Town of Gorham Planning Board Meeting April 1, 2024

ITEM 8 <u>Discussion – Site Plan Amendment – GenX Capital Partners, LLC.</u> – Luxury Motor **Toys** – a request for site plan amendment for approval of 40 condominium garage units with associated clubhouse. Zoned Olde Canal Industrial (OCI). Map 34, Lot 3.003. Represented by Jon Whitten, Jr., P.E. with Haley Ward.

As requested by the Town of Gorham, Wright-Pierce has reviewed the Non-Residential Major Amended Site Plan application for the proposed 40 garage condominium development under the brand "Luxury Motor Toys". The project property is located at 65 Olde Canal Way in Gorham and has previously been approved for development under different applicant entities. The proposed project is on Lot 3 of the second Amended Subdivision Plan and is in the Olde canal Industrial Zone, and is identified as Map 34 Lot 3-3 on the Town of Gorham's municipal tax maps.

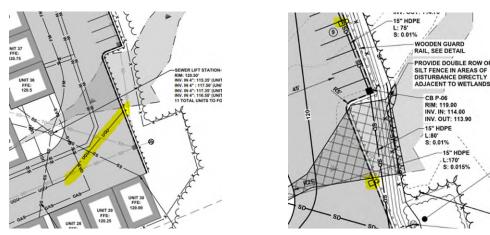
- The structure information for CB P-07 indicates an in and an out; however, only an out is shown on the plan.
- Consider showing additional spot grading, especially on the west side of the site to show stormwater flow away from the buildings.
